**PLANNING COMMISSION
THURSDAY, APRIL 7, 2022 6:00 PM**

1. Application 2022-5014; 7332 E Main St; Main and Lancaster Development Major Site Plan; Applicant: Tim Spencer Trivium Development LLC

RE: East Main and Lancaster Ave – Major Site Plan #2022-5014 Staff Report

On behalf of the City of Reynoldsburg, EMH&T conducted a preliminary engineering review of the private development plan for the proposed project at 7332 East Main Street which is also known as the Happy Dragon site. The following summarizes our findings and recommendations with respect to this development.

NLS LIGHTING
 Trivium Reynoldsburg
 Lighting Dynamics INC
 Date: 03/28/22

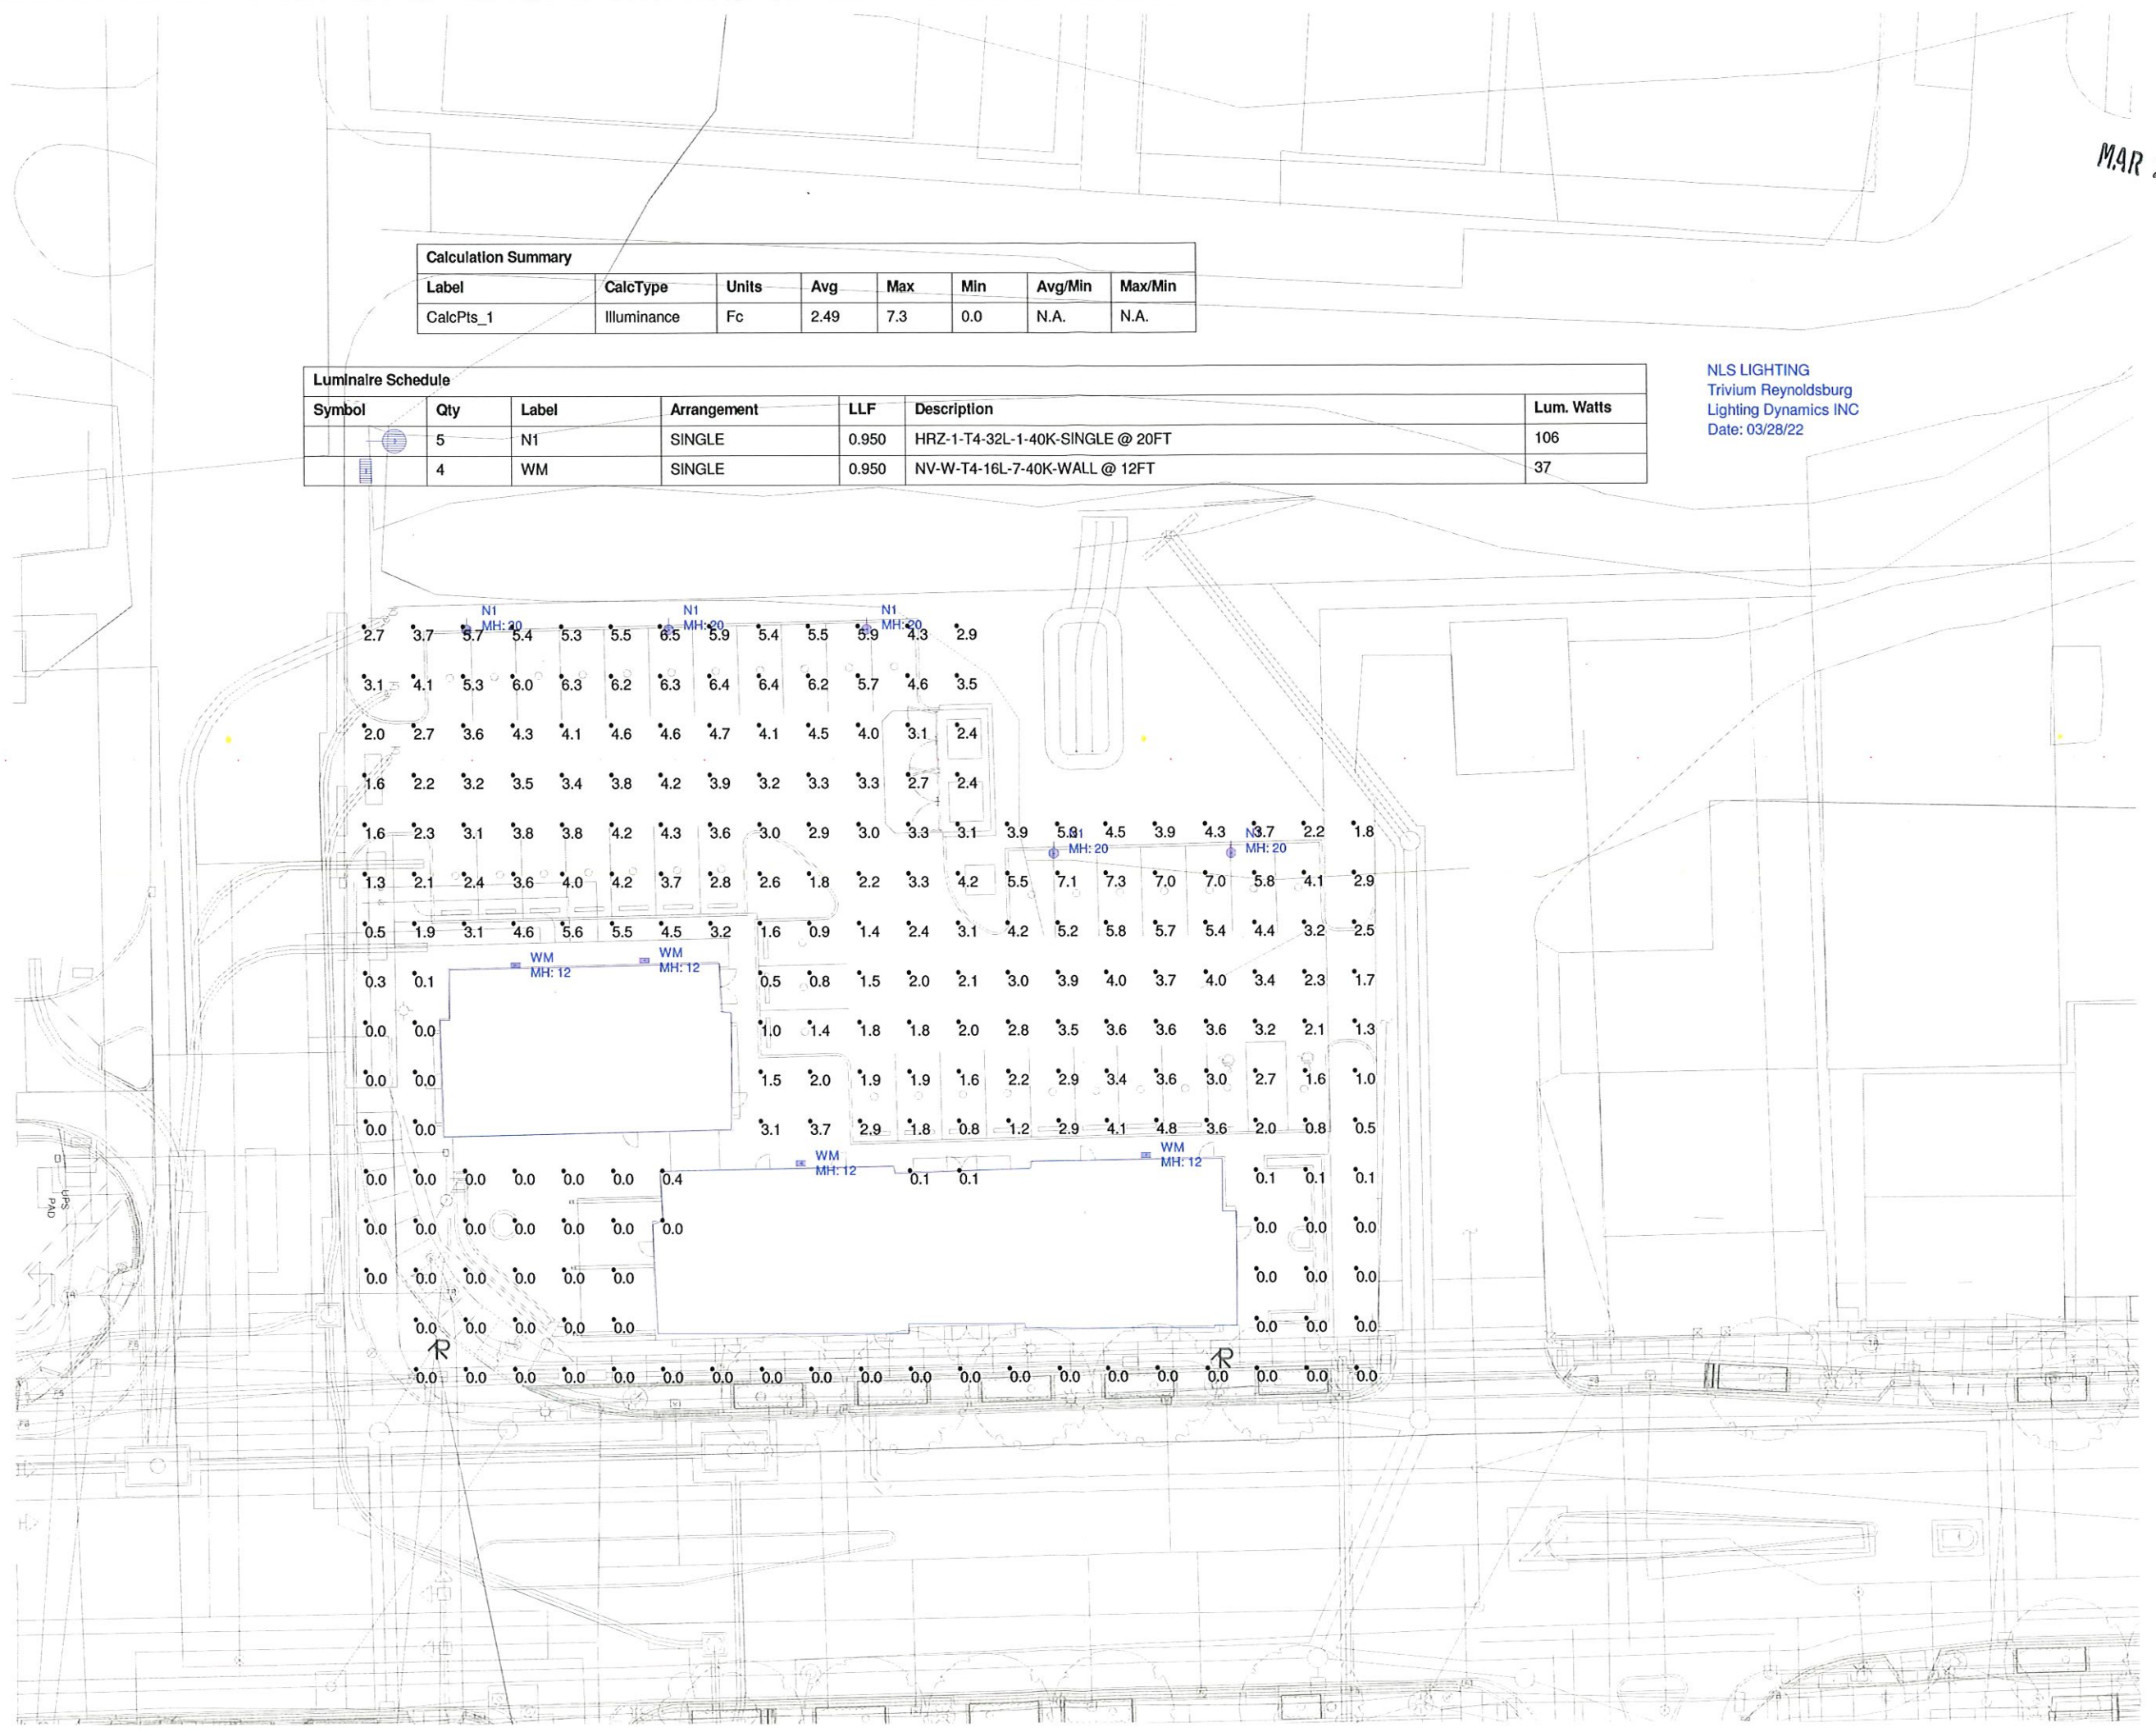
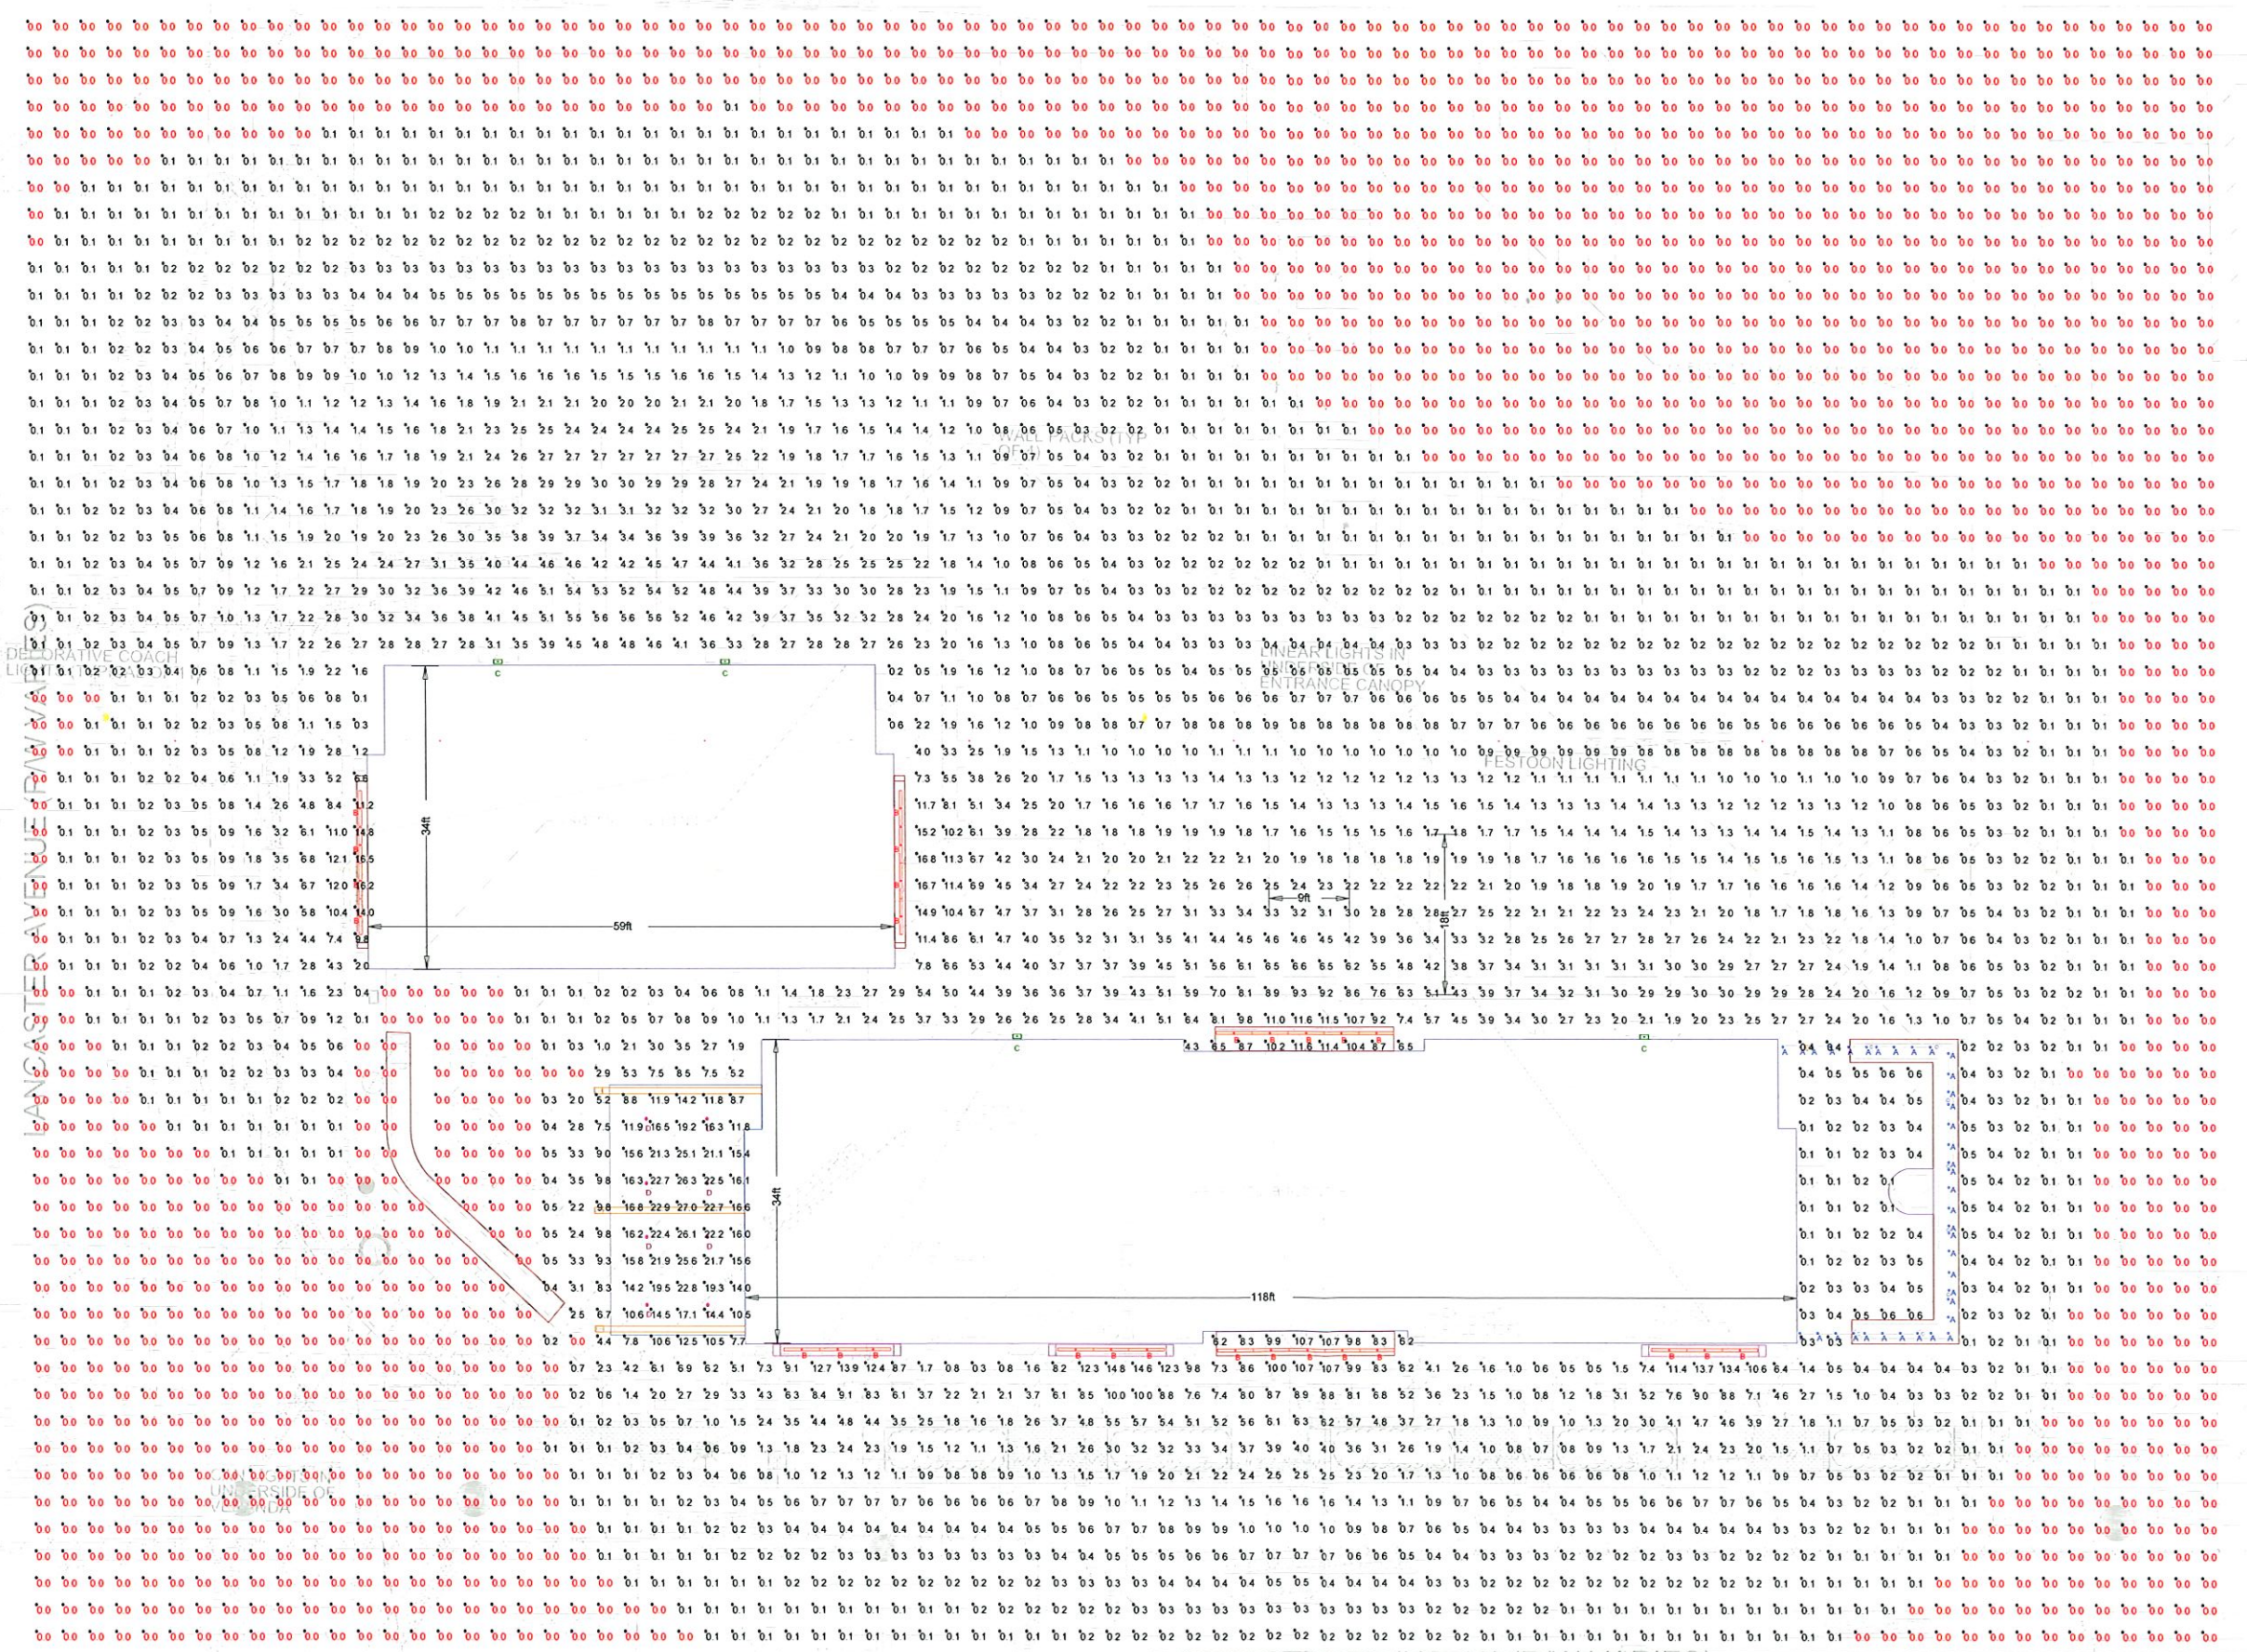
13. For lighting, the project is proposing to use post-top style LED lighting along the rear property line and in areas to the east to light the parking areas. Wall mounted lights are proposed all around the building to provide lighting adjacent to the building.

- a. Please continue to coordinate with the City’s East Main Street team for the lighting along the street.
 - b. The photometric analysis is adequate for the parking areas and behind the building. Please show the wall pack lights on the street side so it can be factored into the model. Also, please consider the addition of a light post on the east side of the building to better illuminate the access drive as it is currently dark. This can be coordinated with the City’s design team as needed.
